14 December 2018

## **345 VICTORIA AVENUE, 12-14 MALVERN AVENUE AND 5-7 HAVILAH STREET, CHATSWOOD NSW 2067 - AMENDMENTS TO DRAFT CONDITIONS**

On behalf of Vicinity Centres (the applicant) we have reviewed the draft conditions issued in respect of DA 2017/503 for the demolition of 2 commercial buildings, reconstruction and expansion of Chatswood Chase Shopping Centre.

**Proposed Elevation - South**

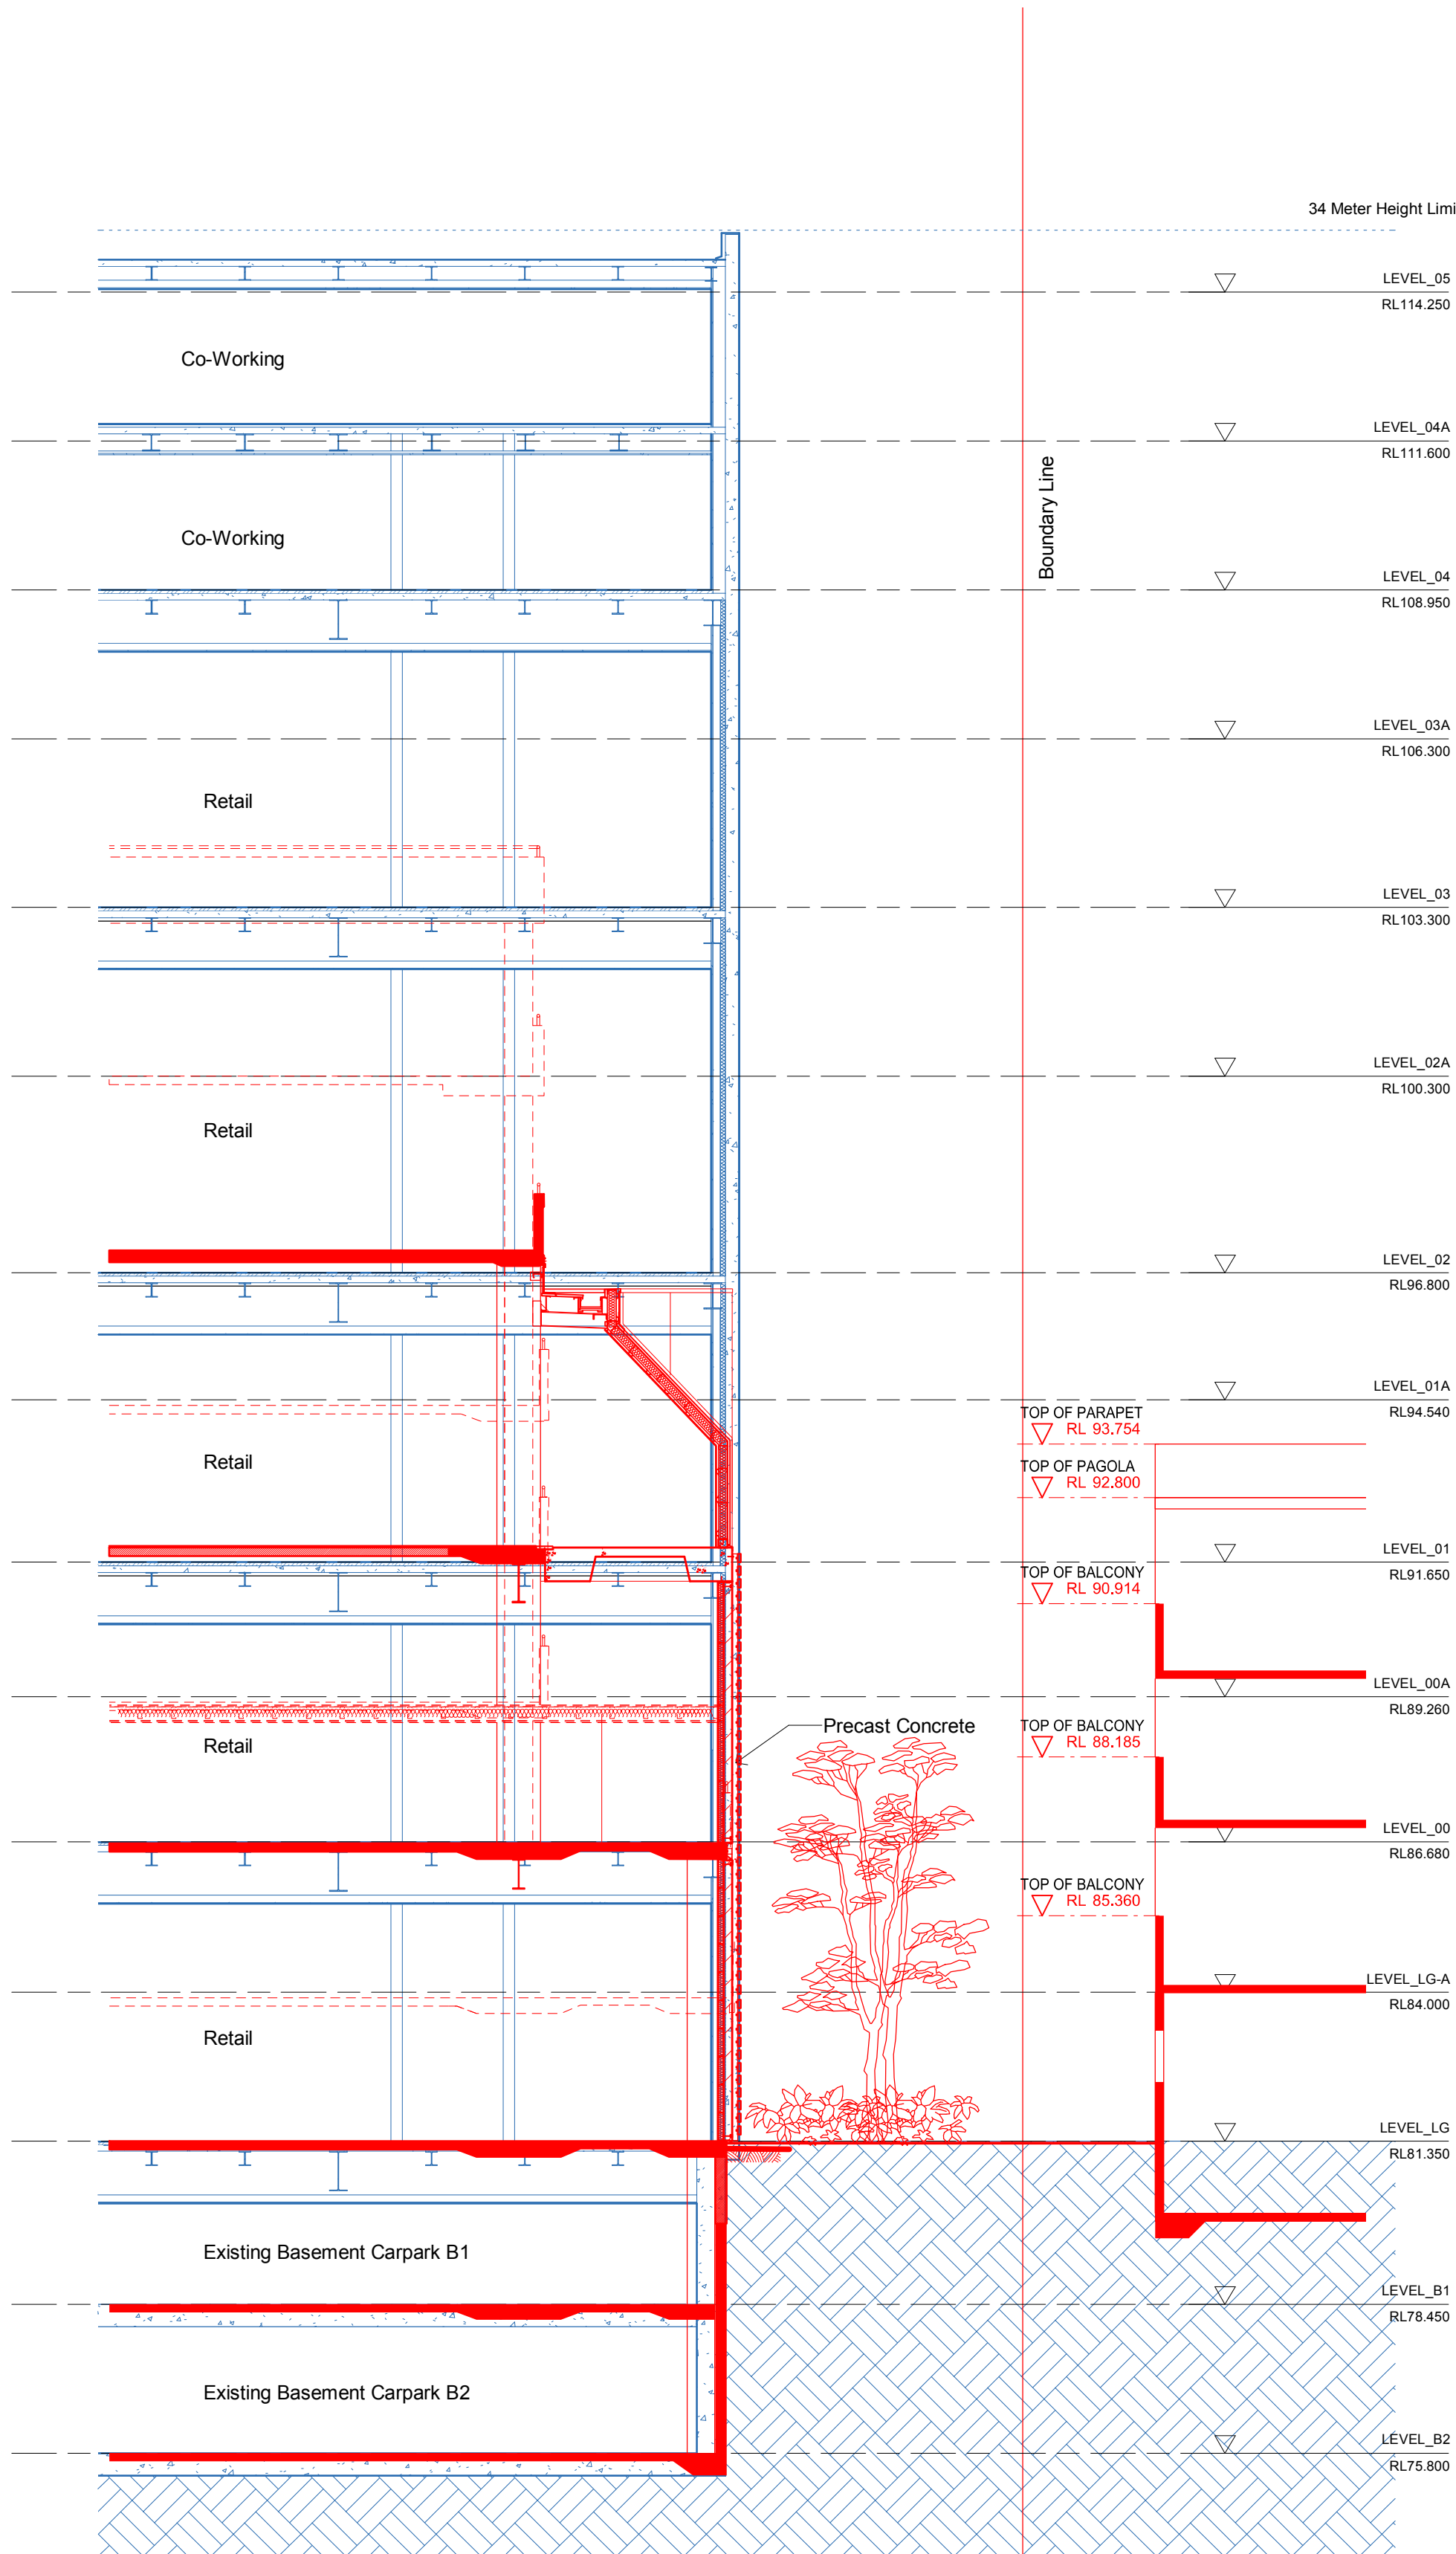
- a) The proposed development shall be modified **so that the portion of the building on the eastern elevation fronting Havilah Street which includes the proposed co-working spaces** complies with the **34m** maximum building height above existing ground level prescribed by Clause 4.3 WLEP 2012. 'Existing ground level' is to be regarded as being equivalent to the natural ground level indicated on the survey plans, rather than being measured from the existing basement level.

- Consent cannot be granted for exceedance in height without a clause 4.6 variation request.
  - Amended plans accompany this submission at **Appendix B** which demonstrate compliance with the 34m height limit.
